# MISSOURI 2019 AIRPORT LIGHTING PACKAGE

## WEST PACKAGE

## ADDENDUM NO. 1

November 2, 2020

DISTRIBUTION SCHEMATIC

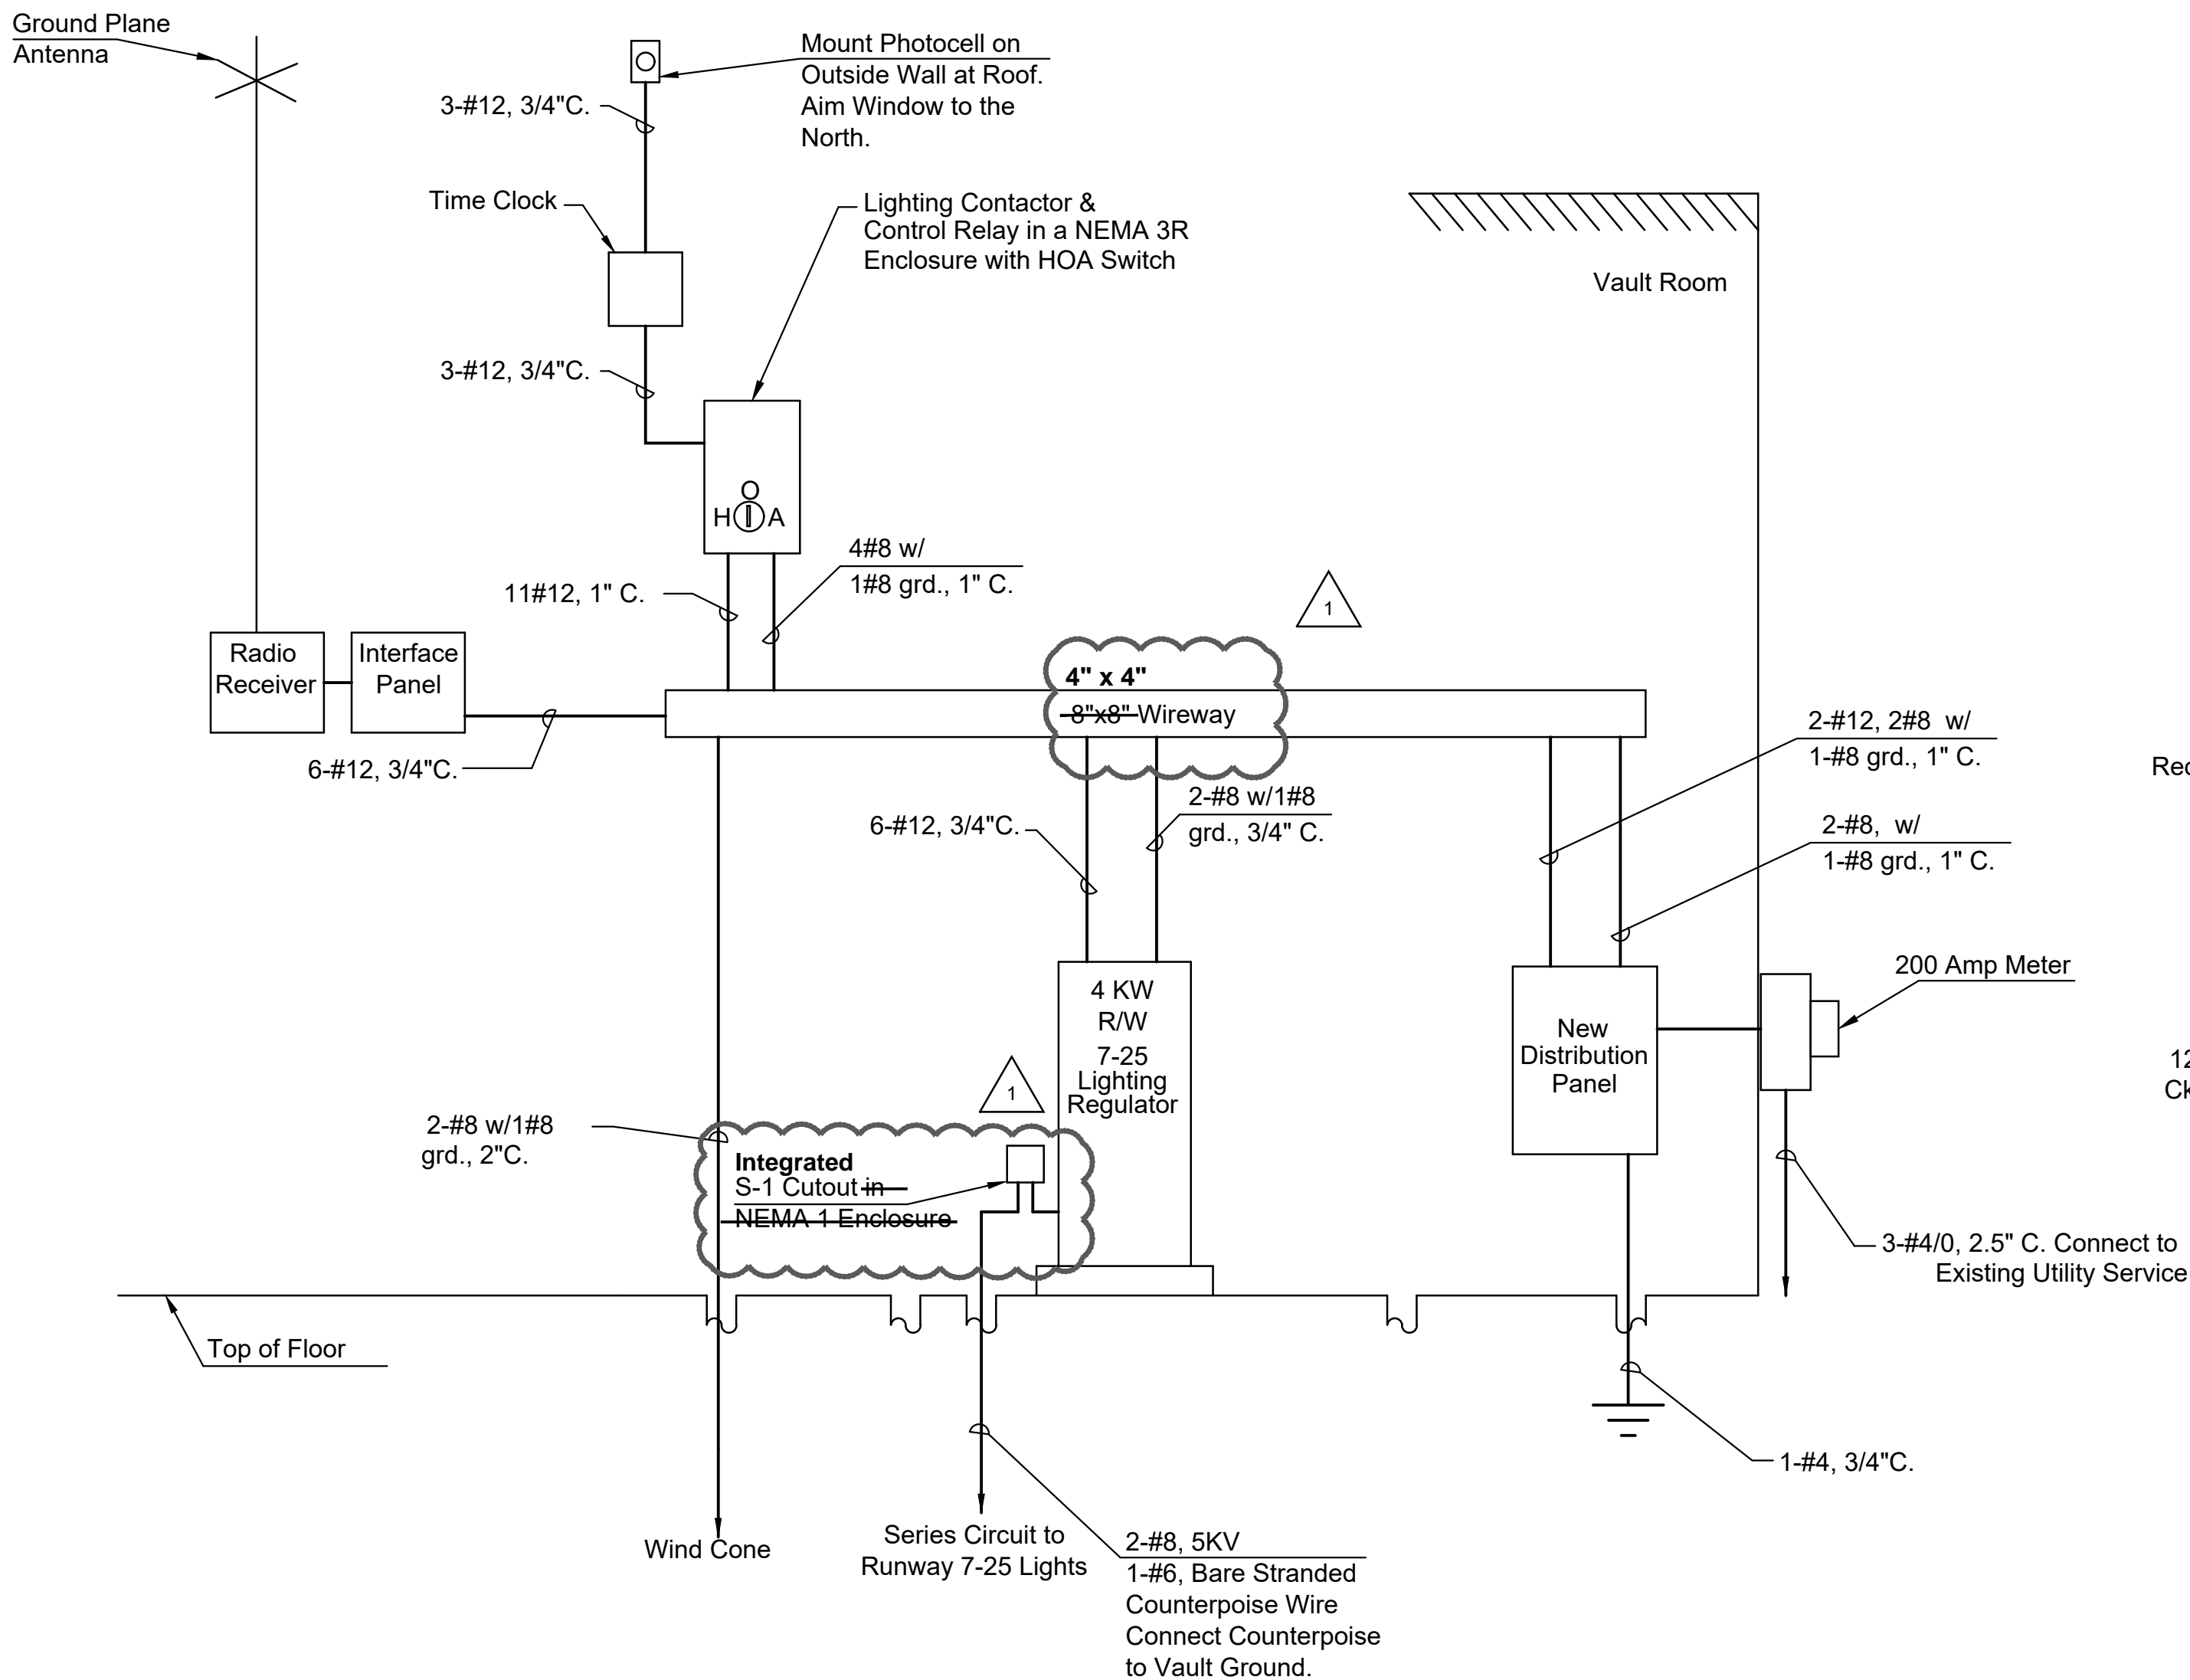
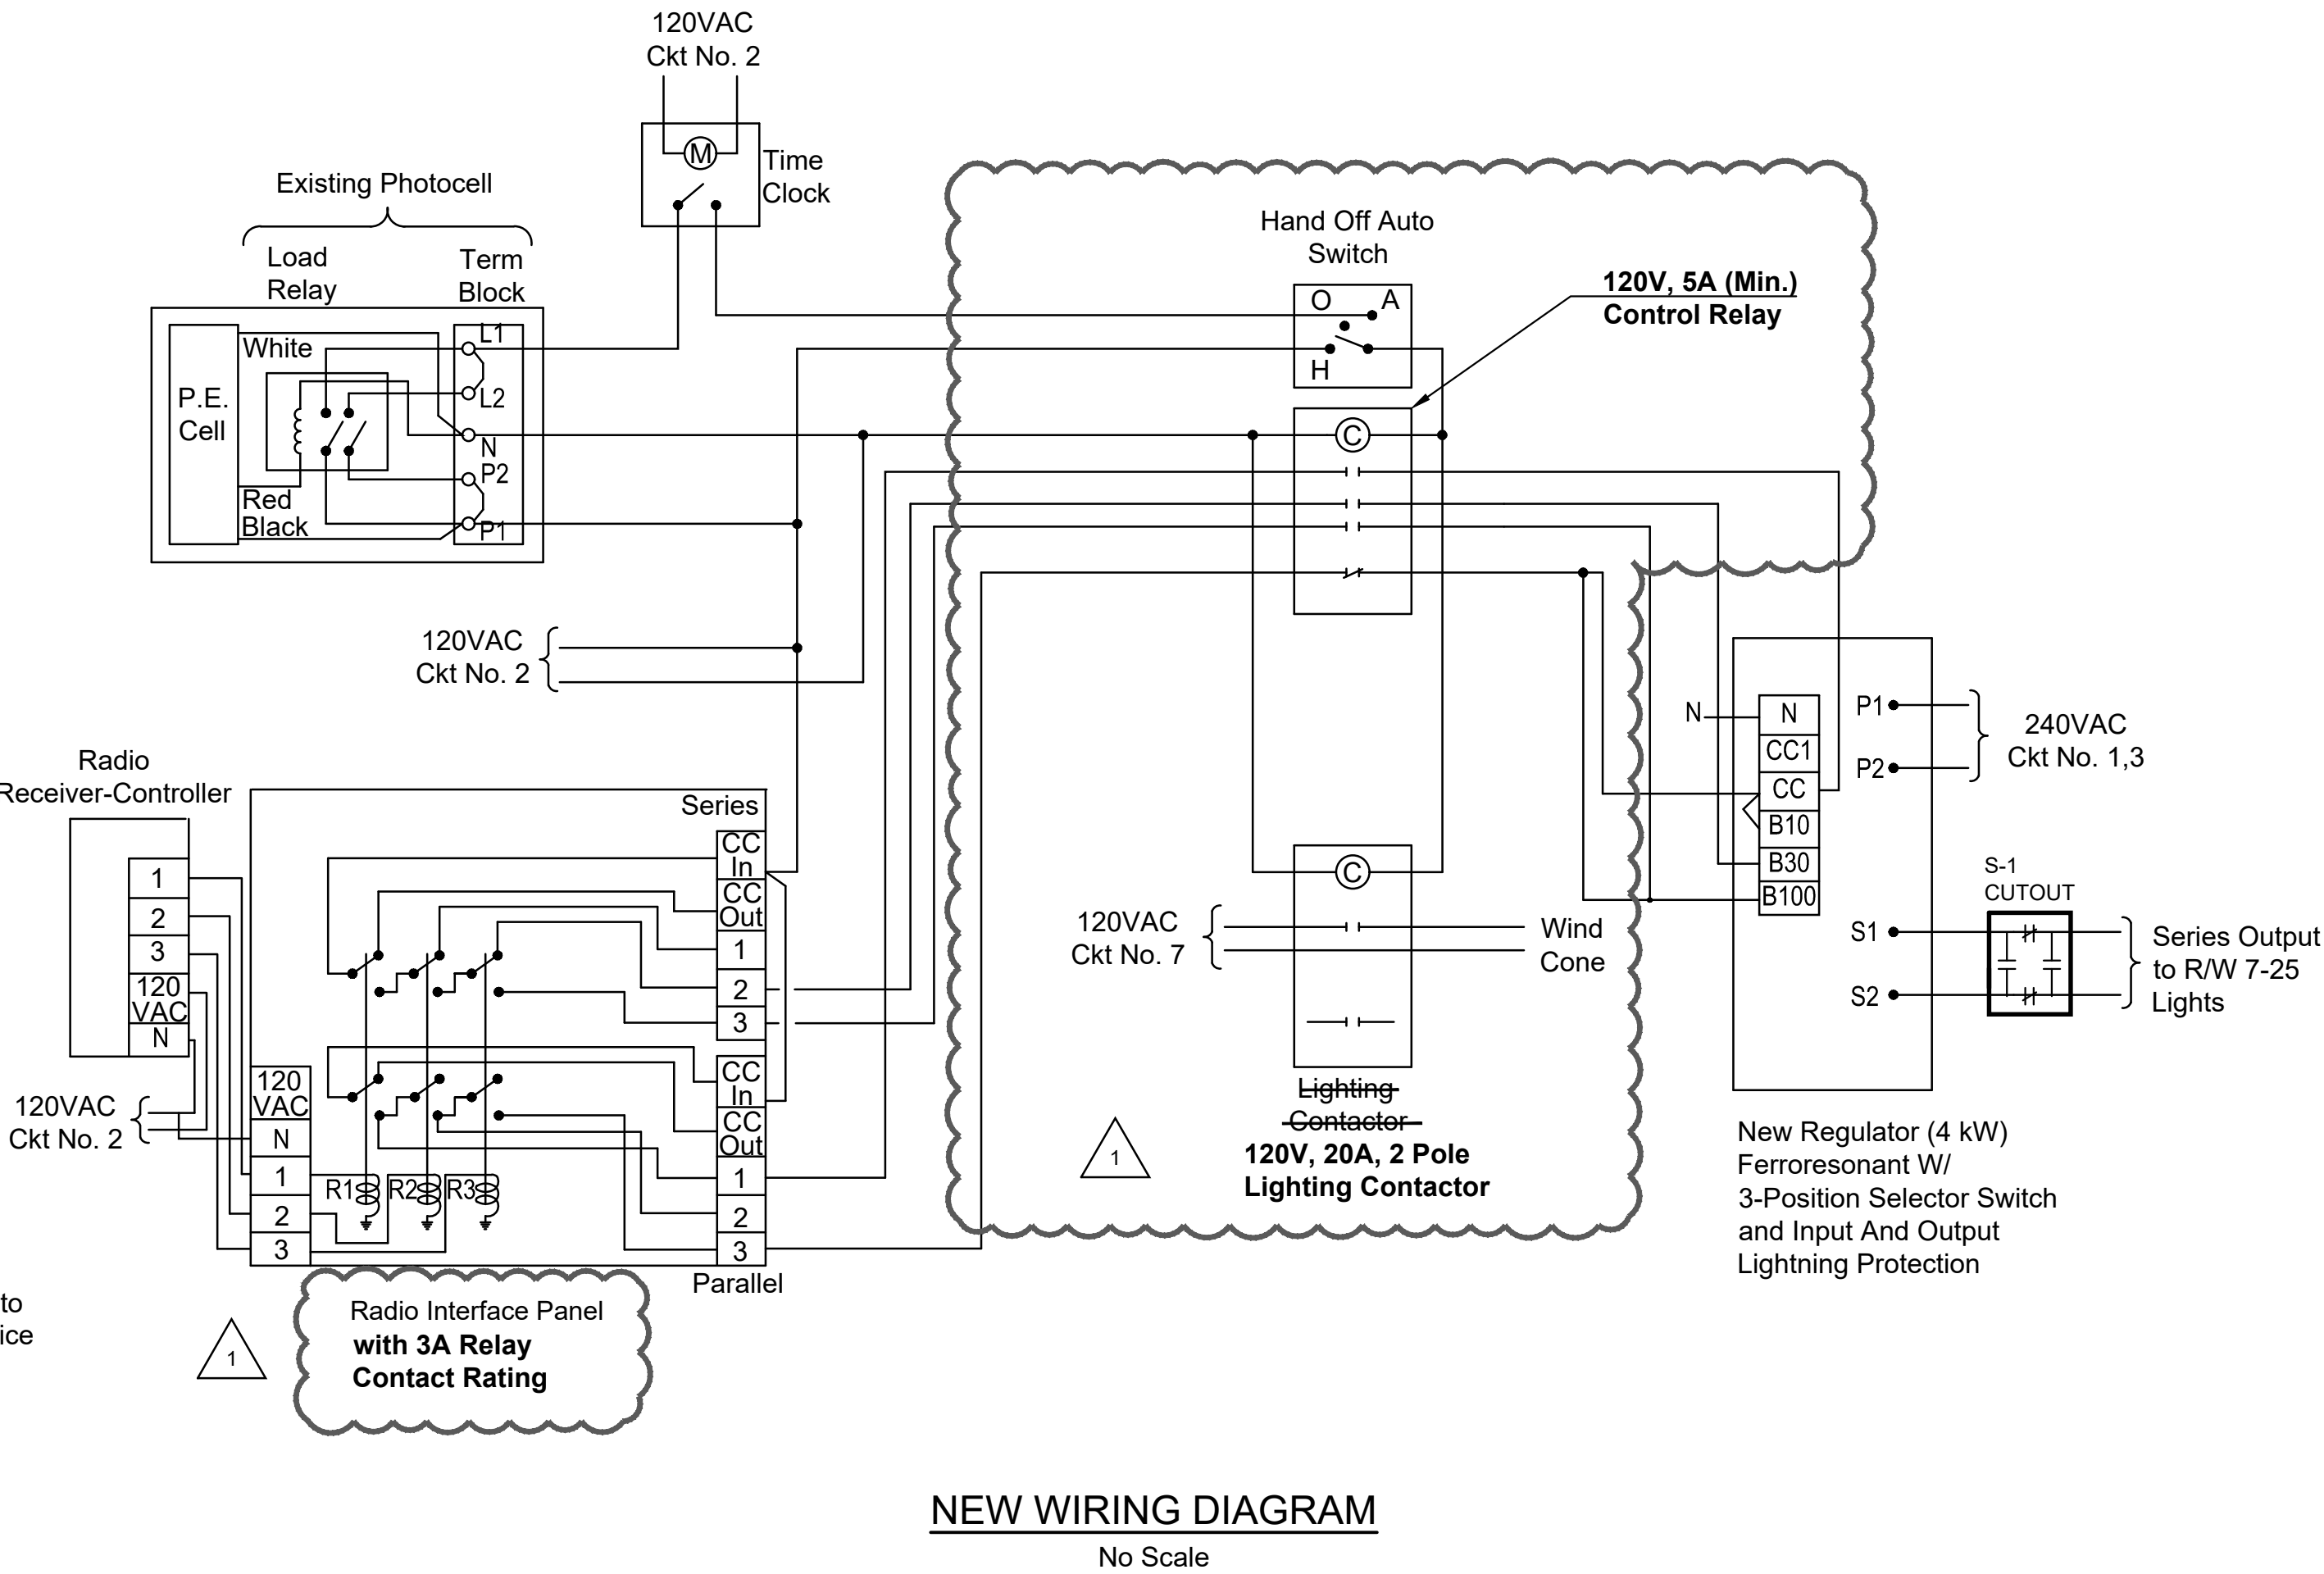
6. **Schedule C: Roy Otten Memorial Airfield**, Sheet No. 13 Distribution Schematic. The 8" x 8" wireway is now a 4" x 4" wireway. The 100A lighting contactor for the regulator and wind cone was removed. The regulator will now be controlled via a 120V, 5A (minimum) control relay and 20A, 2 pole lighting contactor. Radio interface specifications were added to the label, and the callout for the S-1 cutout revised to indicate that this is to be integrated with the regulator. The Distribution System Elevation and Wiring Diagram Schematics were updated to reflect these changes.
